**Liberty School District – LNHS BEST Room Remodel**  
**Addendum No: 02**  
**Description Narrative**  
**April 1, 2024**

**ADDENDUM NO. 02**

Issued: April 1st, 2024  
Project: Liberty North High School - Classroom Remodel  
Project No. 21022  
Owner: Liberty Public School District  
8 Victory Lane  
Liberty, Missouri 64068

**A1 SHEET A621 – INTERIOR ELEVATIONS & TOILET PLANS**

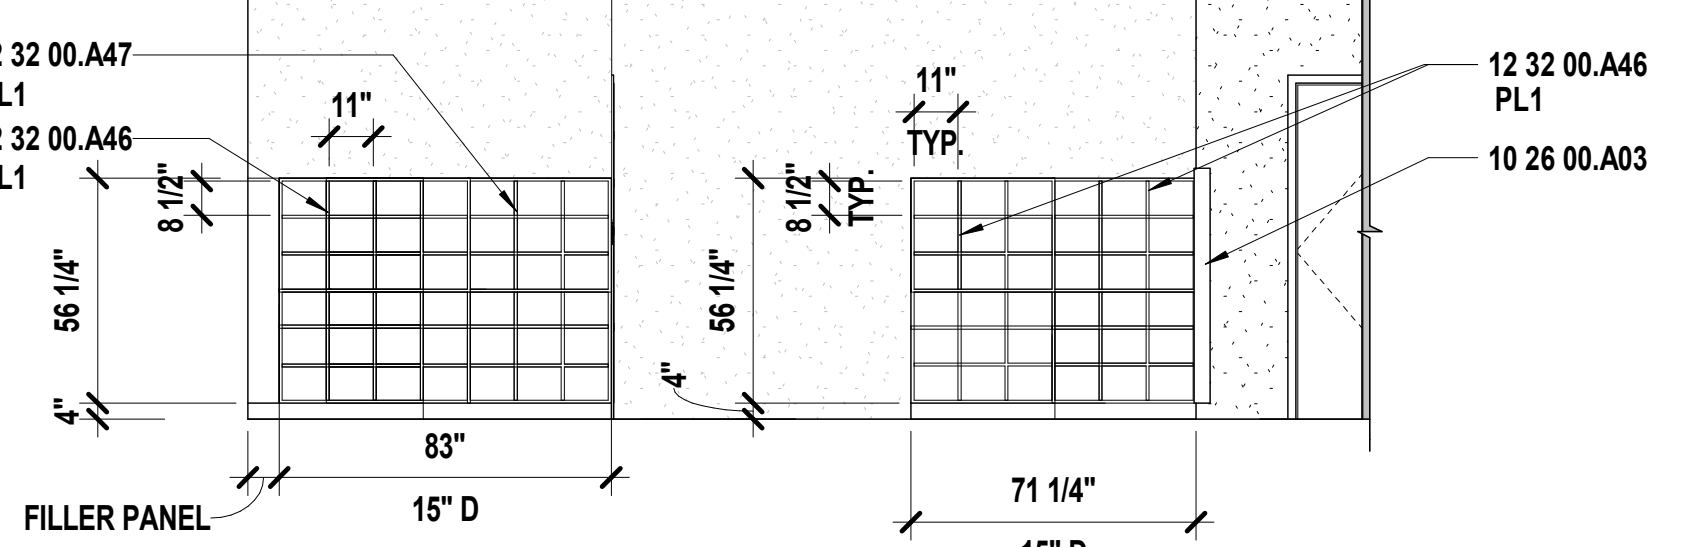
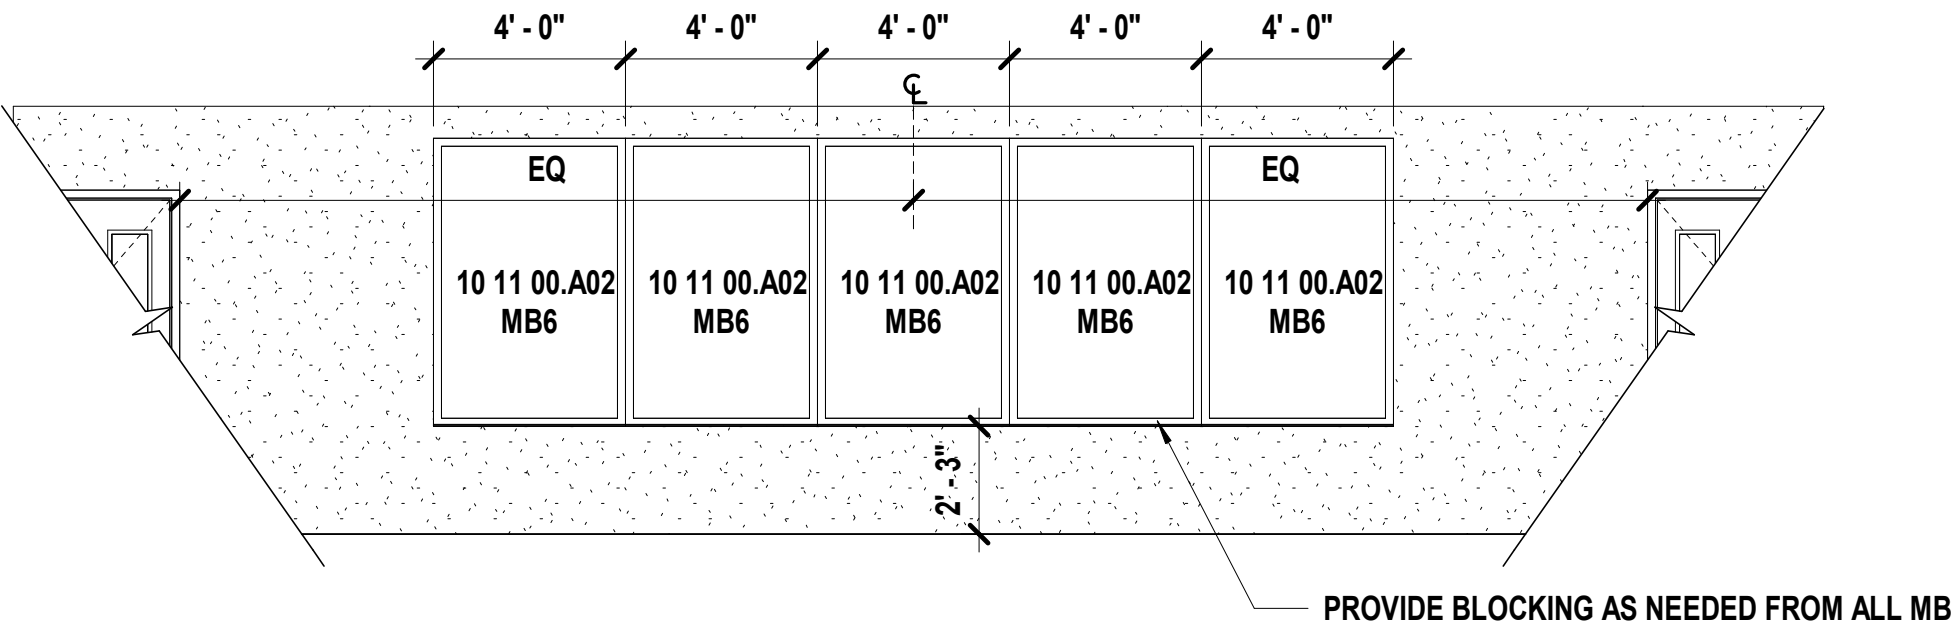
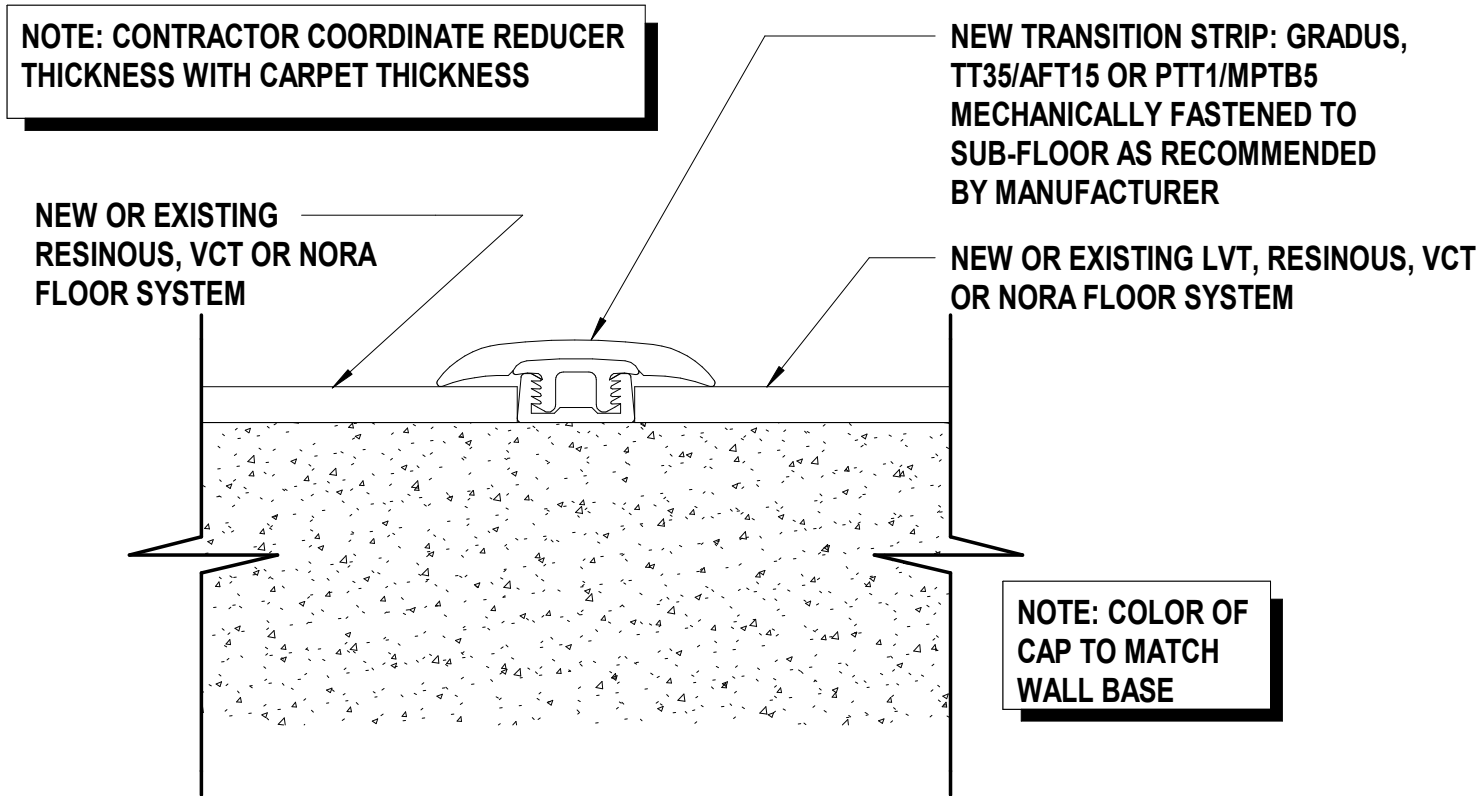
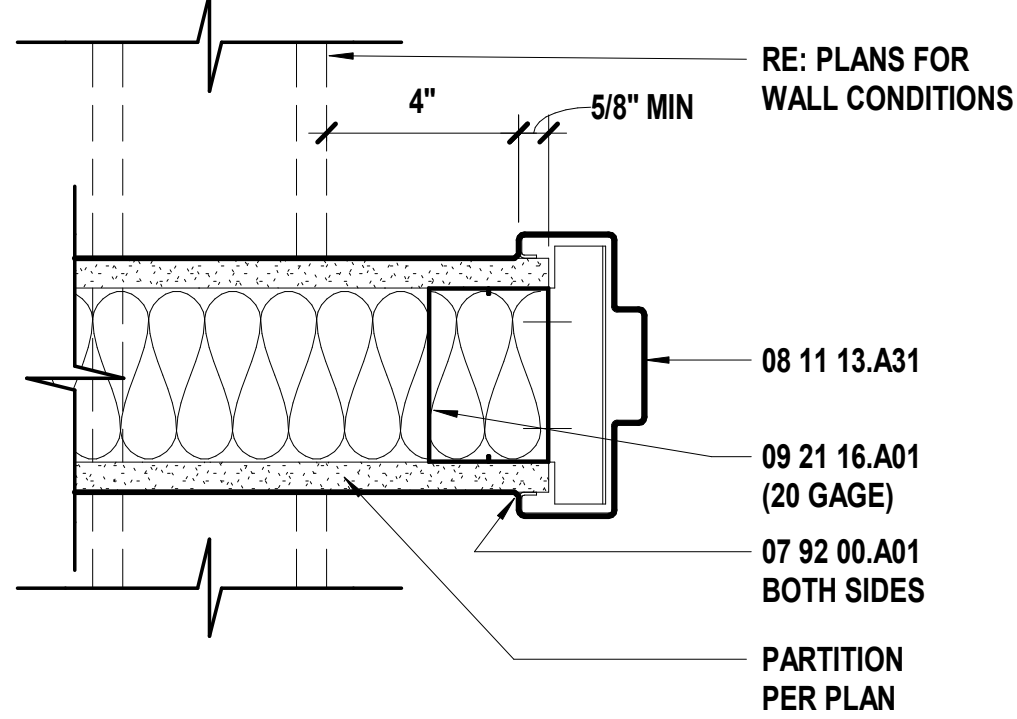
A1.1 Added material finish PL1 to Legend, per attached Sheet A501.
